**Economic Commission for Europe****Inland Transport Committee****World Forum for Harmonization of Vehicle Regulations****158<sup>th</sup> session**

**1958 Agreement – Consideration of draft amendments  
to existing Regulations submitted by GRE****Proposal for Supplement 16 to Regulation No. 4 (Illumination  
of rear-registration plates)****Submitted by the Working Party on Lighting and Light-Signalling\***

Figure 1  
(Marking for single lamps)

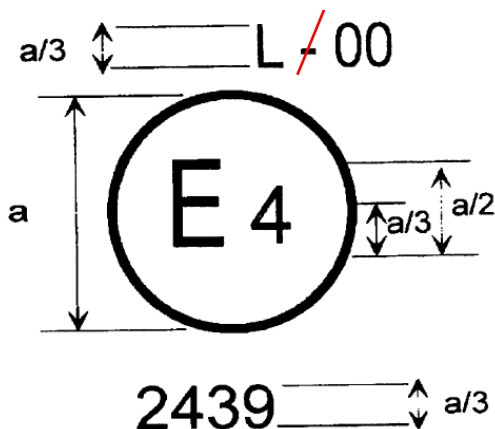
Annex 1, Figure 1, amend to read:

Model A

a = 5 mm min. "
